Product: A/V Receivers

Hardware Technical Bulletin: T763-H2004-02

Subject: Flat Ribbon Cables

Figure 1

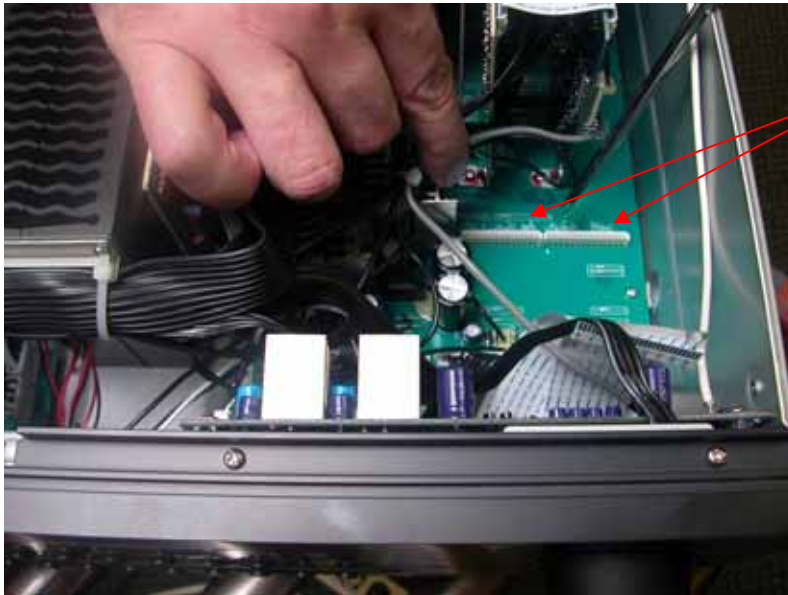
REASON: *The flat ribbon cables, primarily the ones running from the front panel but may include all flat ribbon cables. They may have intermittent contact due to oxidization.*

Locate and remove the ribbon cables, front panel cables shown.

SOLUTION: *Clean all ribbon connectors using an eraser or preferably a non alcohol based cleaner which will leave no residue. See figures 1, 2 and 3.*

Figure 2

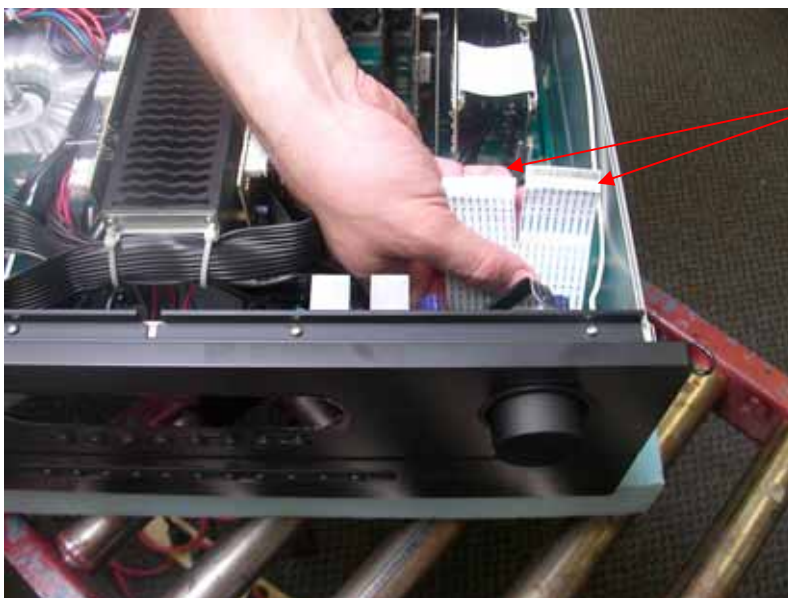
Ribbon cables are easily unplugged from these connectors.

Clean the ends of the ribbon cables with eraser or non alcohol based cleaners.
